# CITY OF CONWAY, ARKANSAS HISTORIC DISTRICT COMMISSION

September 26, 2022 • 5:30pm • 1111 Main Street

## HISTORIC DISTRICT COMMISSION

Applicant provided sketch of proposal

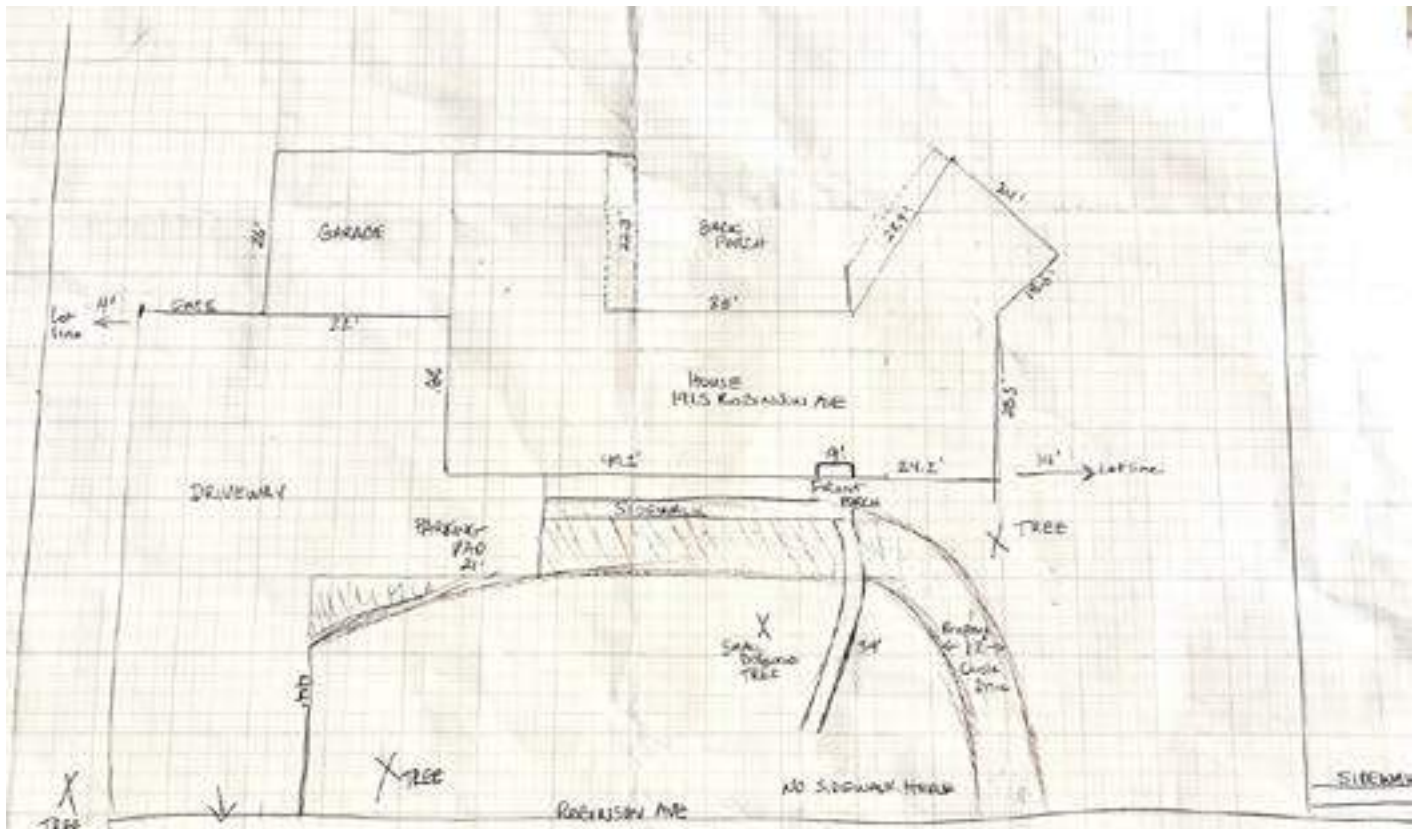
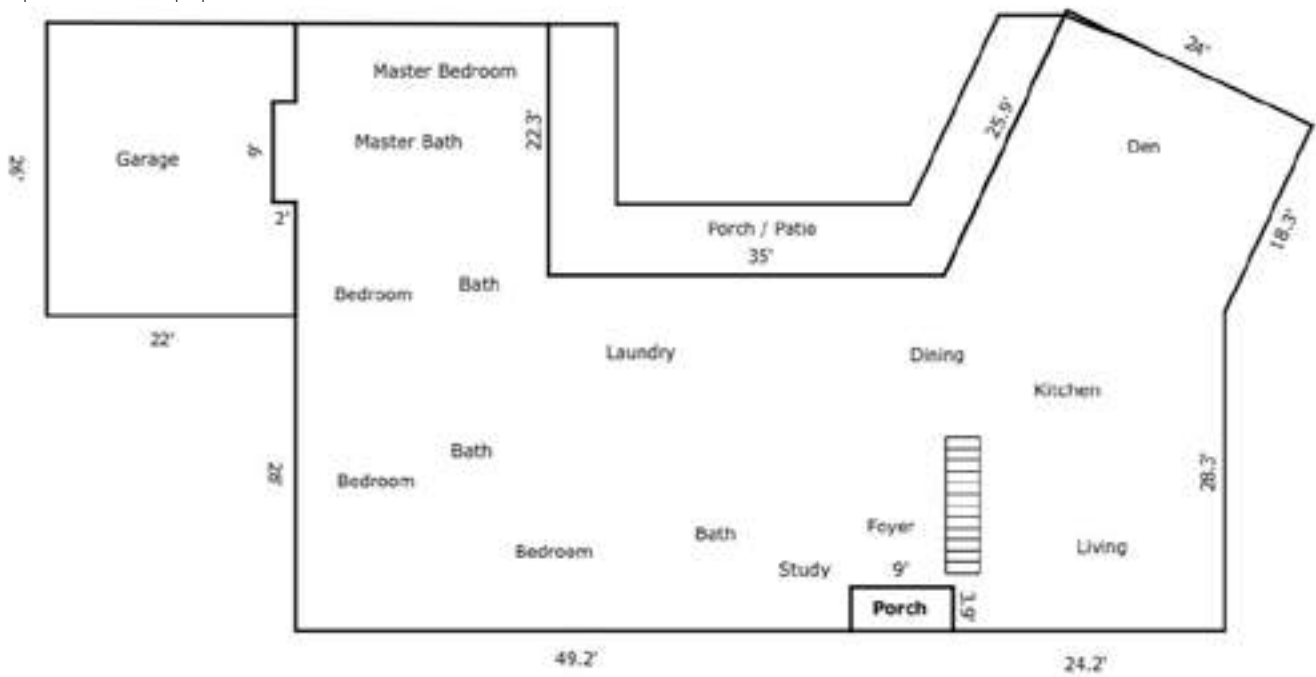
*The applicant intends to place a new circle driveway in the front yard. This will likely impact existing trees in the front yard. Circle driveways are directly discouraged in the Robinson District Guidelines. While circle driveways exist outside the district in the Old Conway Design Overlay District, the only circle driveways in the Robinson District exist for institutional uses such as First Baptist Church. The proposed request does not appear consistent with the guidelines established for the Robinson District.*

Staff recommends denial of the project as the proposal does not appear consistent with the Robinson District Guidelines; circle driveways are directly discouraged in the guidelines and no residential circle driveways exist within the district.

1 835 FAULKNER SITE PLAN  
SCALE: 1/8" = 1'-0"

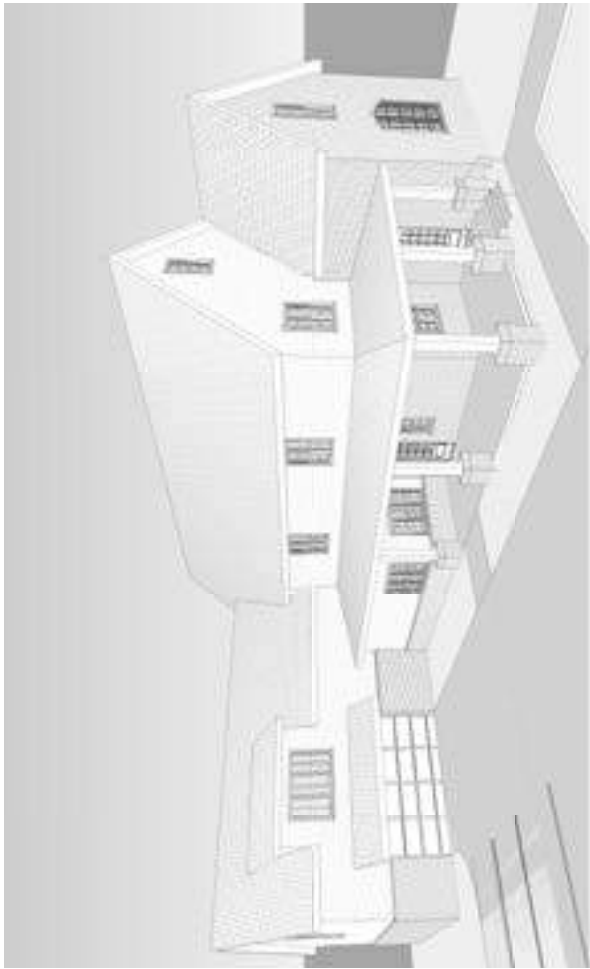
*The site plan does not appear to reflect the depth of the property's boundary (145' as platted. GIS data indicates 145' from the back of sidewalk to rear parcel line). As measured from aerial data, the average setback along the block face is 27.5'. Based on this the proposed setback needs to be placed between 23.5' and 32'. To meet this requirement the structure needs to be moved 16' closer to the street.*

8. The structure shall be placed between 23.5'-32' from the front property line.
9. Any damaged sidewalks shall be repaired/replaced.
10. **Submit revised drawings to the Planning Director for approval prior to release of the COA.**

1 SOUTH ELEVATION  
SCALE: 1/8" = 1'-0"

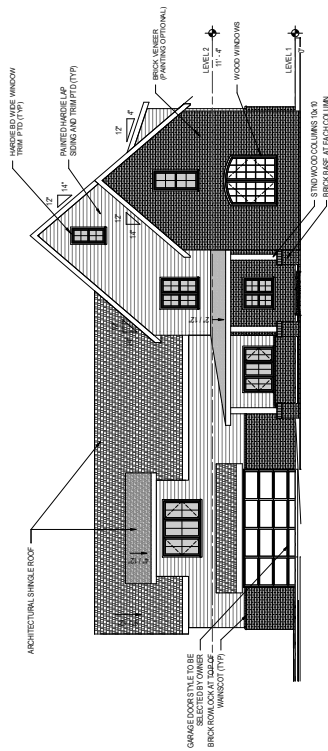
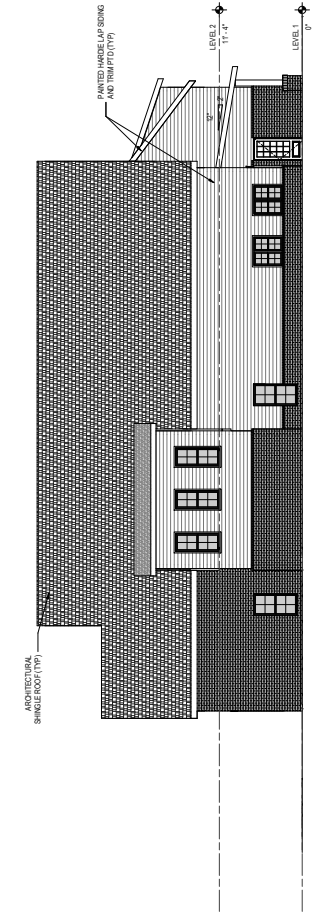
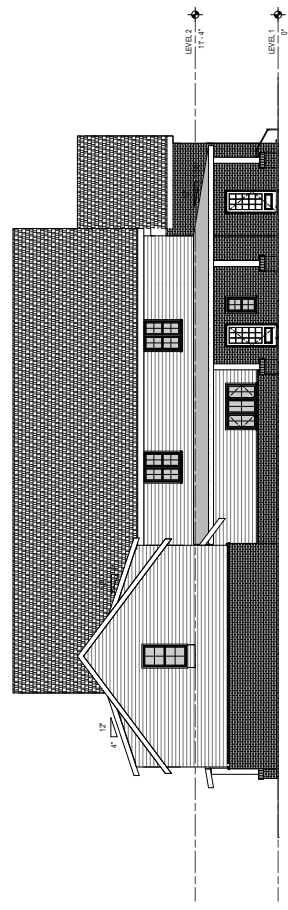
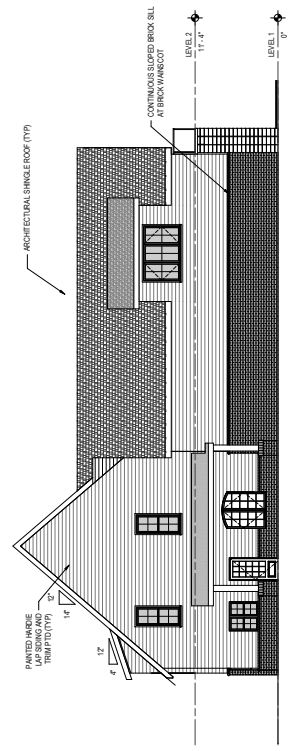
*The site rests within an area with a high variability of style, use, and design. The design will feature a residential style with porches that complement the surrounding area. Proposed materials will be compatible. Recommend requiring windows be one-over-one wood clad vinyl/ vinyl windows or true divided light windows.*

1. Require the proposed columns be at least 8" in width.
2. Require use of materials indicated in the proposed application.
3. Require fascia and soffits to be finished with wood or wood equivalent construction (Hardie® siding/LP SmartSide®).

4. Require all windows be one-over-one design and feature wide trim or be true divided light. Windows may be wood, wood clad vinyl, or vinyl.
5. All HVAC and mechanical equipment shall be screened or placed in a manner to reduce visibility from the street.

**West Elevation**

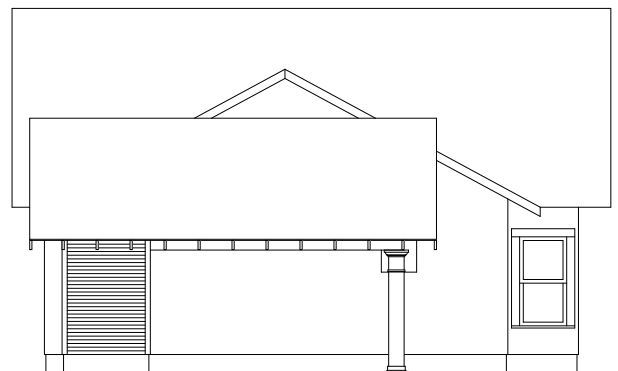
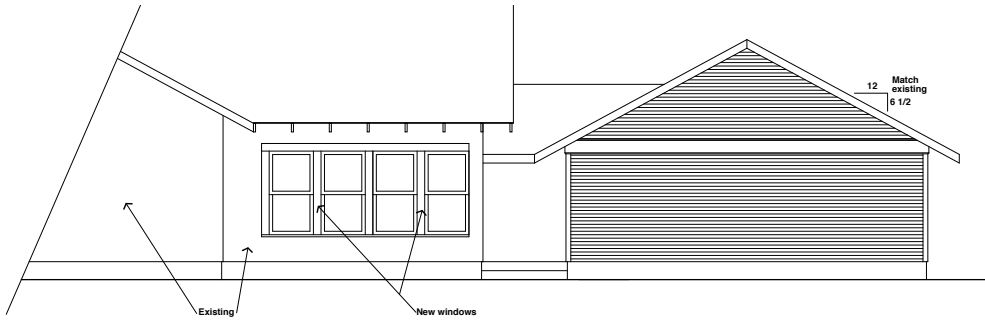
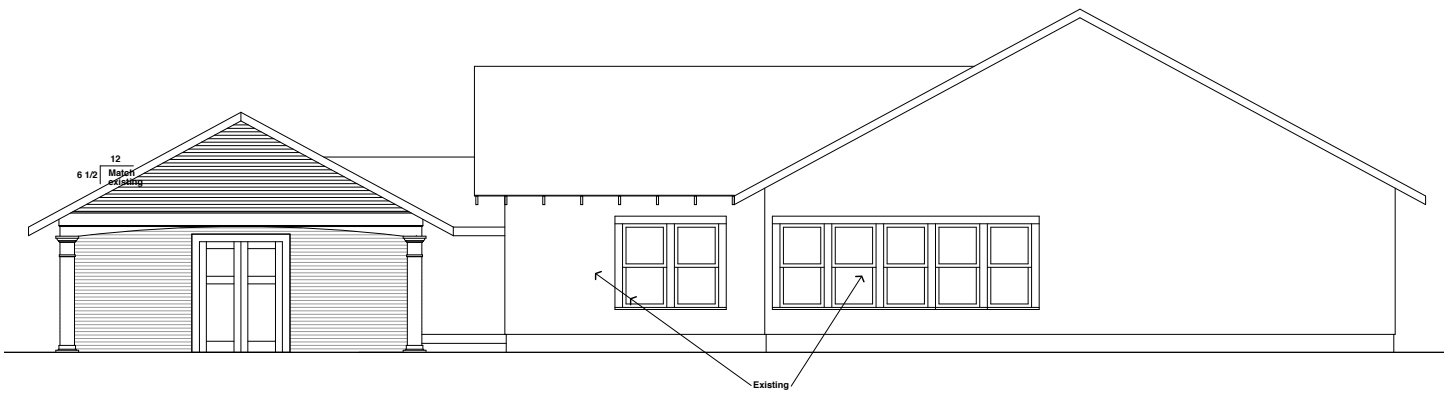
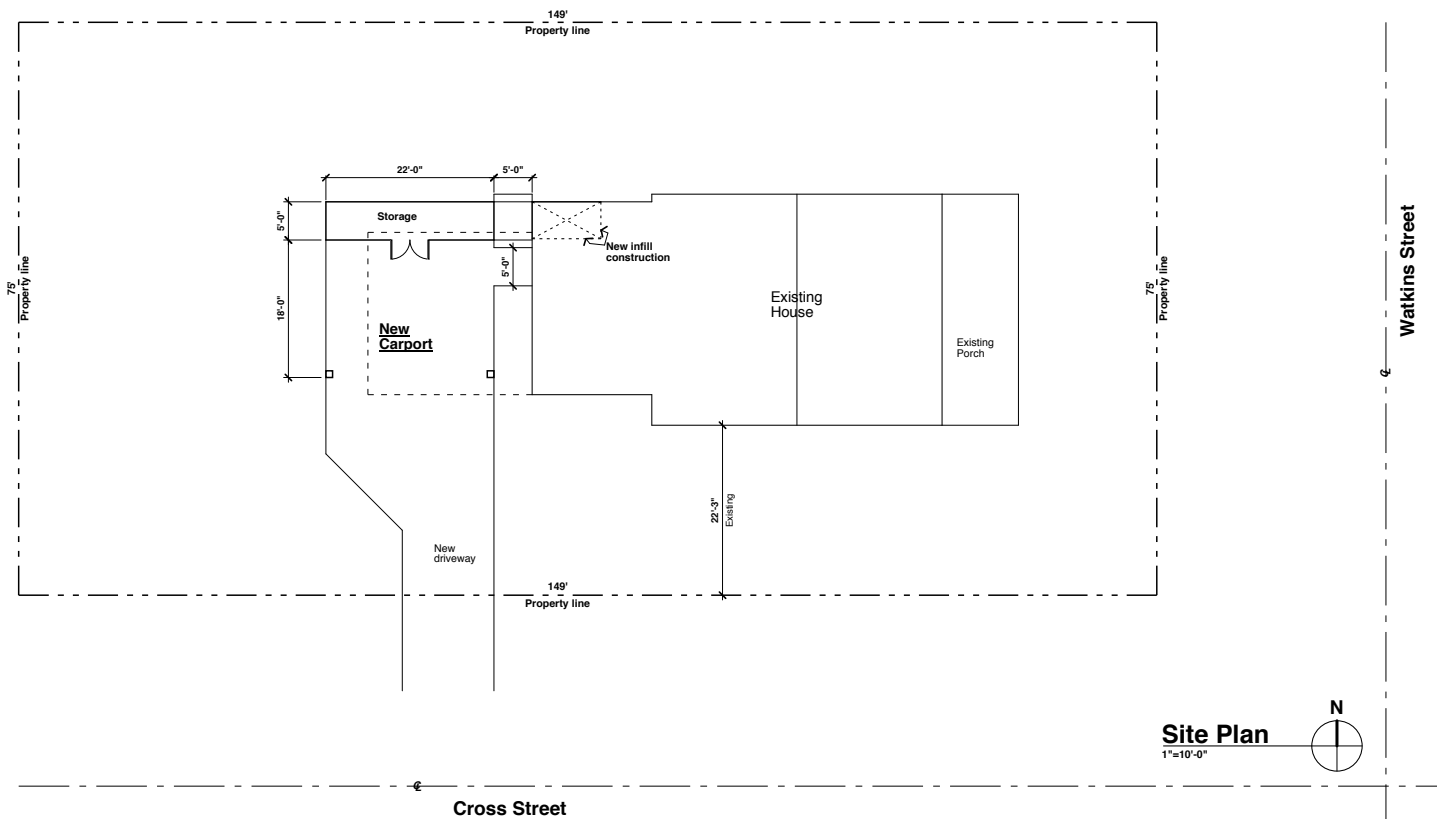
*New windows will be added on the north elevation and west elevations. Proposed windows are indicated as one-over-one with wide trim. Proposed windows appear appropriate to the structure.*

*The applicant hasn't indicated materials for construction. Recommend requiring use of wood or wood-equivalent materials like Hardie® siding/ LP SmartSide® for the project. Exposure of siding should match the existing siding for the structure.*

1. Require fascia and soffits to be finished with wood or wood equivalent construction (Hardie® siding/LP SmartSide®).
2. Require the exposure of new siding to match the existing siding of the structure.
3. HVAC equipment be placed in a manner to minimize its visibility from the street.
4. Require all windows be one-over-one design or single pane in design with wide trim.
5. Require wood, Hardie® siding, or LP SmartSide® lap siding to be used on the structure.
6. Require the planting of one tree to replace the tree to be removed.

EXTERIOR RENDERING

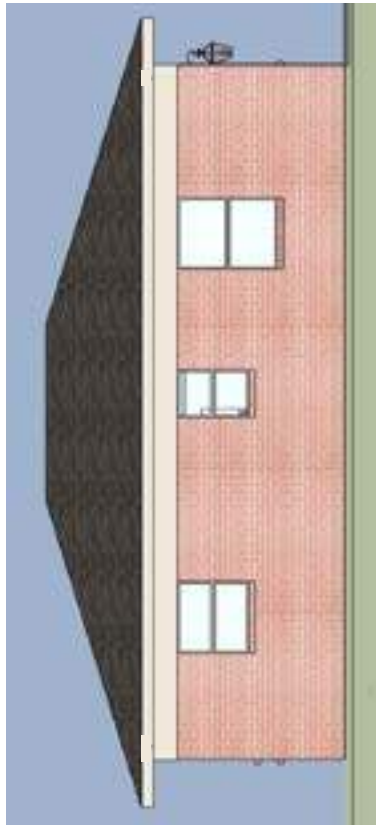
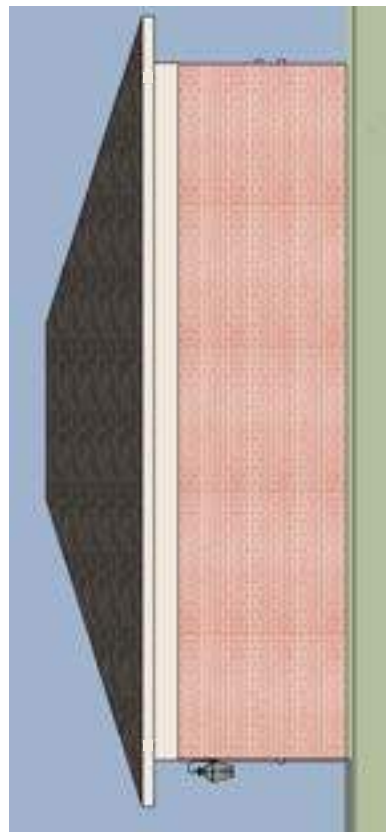
*The applicant is proposing several openings to the front, rear, and left elevations. These include several windows, most which are existing, and a door facing the street. The addition of two windows to the right elevation is recommended to meet the design aesthetic of the district.*

*Most windows shown on the elevation plans are existing. Any new proposed windows will need to be one-over-one. Details for both windows and door will need to be provided prior to approval.*

*The applicant is proposing to fully brick each side of the accessory dwelling. The brick should be of high quality and match the brick found on the home. Any damaged, cracked, or missing bricks shall be repaired.*

1. Require fascia and soffits to be finished with wood construction or wood substitute such as Hardie® siding/LP SmartSide® and painted/repaired.
2. Two windows are required on the right elevation.
3. Specifications for new windows and door will need to be provided. one-over-one windows required.
4. Any new HVAC equipment must be placed in a manner to minimize its visibility from the street and screened by landscaping.
5. ***The applicant shall provide revised plans to the Planning Director for review and approval prior to issuance of a Certificate of Appropriateness and building permits.***

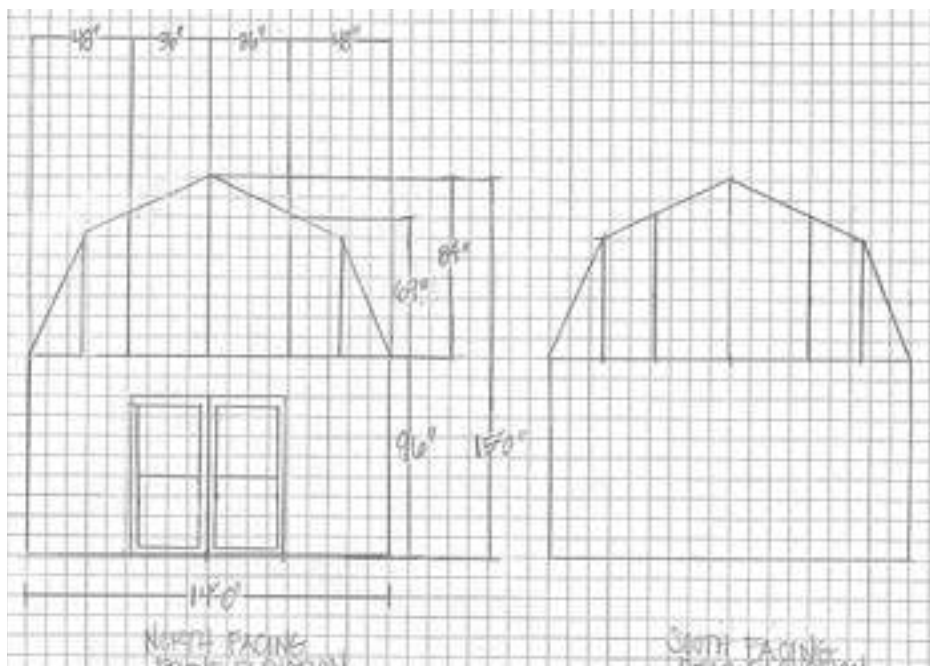
*The proposed roofing slopes for the garage is 4/12 and will not match the house. However, the structure is small. Recommend requiring an asphalt shingle roof to match the house.*

1. The roofing materials for the structure shall consist of asphalt shingles.
2. The structure and all fascias and soffits shall be constructed with wood or a wood-like material such as Hardie® siding/LP SmartSide®.
3. HVAC equipment be placed in manner to prevent view from the street or screened by landscaping/fencing.
4. **Existing accessory structure on site, not reflected on site plan, shall be removed prior to issuance of a Certificate of Appropriateness. If structure is to remain a revised site plan, including size of existing structure, shall be submitted to the Planning Director prior to issuance of a Certificate of Appropriateness.**
